PPC Application – Clause 23 Requests from Auckland Council including Further Information Requests

Applicant: Aedifice Development No.1 Limited  
 Address: 47 Golding Road and 50 Pukekohe East Road, Pukekohe  
 Proposed activities: PPC – Pukekohe East-Central Precinct 2

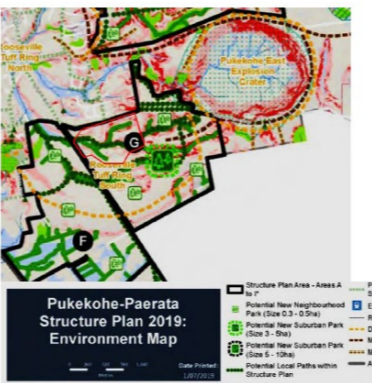
#	Category of information	Clause 23 Specific Request (19/09/22)	Reasons for Request	Applicant Initial Responses (30/09/22 and 07/03/23)	(Clause 23 (2)) Councils Further Requests Arising from Applicant Responses (16/03/23)	Applicant Responses to Further Requests (20/07/23)
			<p>The map (above) (reasons for requests) shows the <b>revised</b> locations of open space across the Pukekohe-Paerata Structure Plan area based on a service needs gap analysis.</p> <p>This supersedes the indicative locations shown in the structure plan. The neighbourhood park is no longer required between Golding and Ngahere Road. The existing open space (Roosevelt Park; approx. 11.4ha) meet council open space provision targets for that area, particularly a neighbourhood park within 400m walking distance for that area and so the gap location has been demonstrated to the north west, within this particular precinct plan.</p> <p>There is a gap within the open space provision policy to adequately secure the provision of a neighbourhood park for future communities that will meet the open space provision policy.</p> <p>The reason why we say it must meet open space provision policy is threefold:</p> <ol style="list-style-type: none"> <li>1) to make sure the park demonstrated is more or less of the location and standard that enables council to acquire that land for the communities in the future.</li> <li>2) ensure any developer in the future secures the provision of this open space as part of their development that will enable them to demonstrate meeting open space provision policies as required under both the NPS-UD and underlying AUP zoning Policies.</li> <li>3) The location of such a park (3-5ha) can have a spatial effect on the master planning of any new development that affects road layouts, access etc.</li> </ol> <p>The “passive public open space” as demonstrated on the precinct plan does not meet open space provision policy in terms of shape size and accessibility.</p> <p>We require a neighbourhood park located more centrally within the precinct plan, that can be fronted by a minimum of two roads to meet the gap within the open space provision policies</p>
